**CITY OF KEY WEST
Schooner Wharf Project
Addendum No. 4
July 19, 2012
ITB PROJECT No.:12-026**

SCHOONER WHARF REBUILD ITB is amended as follows:

ELECTRICAL RISER DIAGRAM

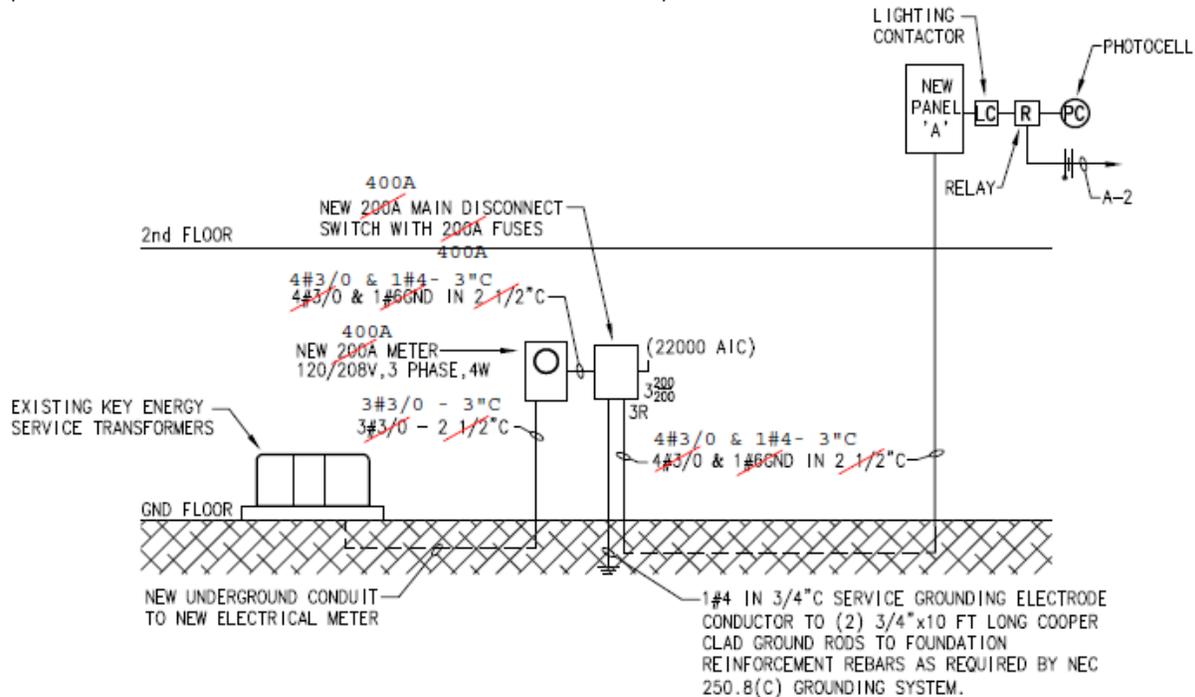
- Sheet E-4, Electrical Riser Diagram: Contractor shall upsize to a 400A Electrical Service. Meter and main switch disconnect to be upsized accordingly. Work will include adding (5) additional receptacle, including conduit and wires (conduit: 3/4"C, wire size: 2#6,1#1G), along the tie beam of the north side of the new structure. Meter, main disconnect, wire and conduit should be priced per redlines shown below on the riser diagram.
ADD Alternate: Contractor should include a separate price to add a second panel 'B' 200A, include upsized conduit, wire, meter, main disconnect switch and all else necessary for a complete and functional installation. Second panel 'B' shall be installed next to the proposed New Panel 'A'.
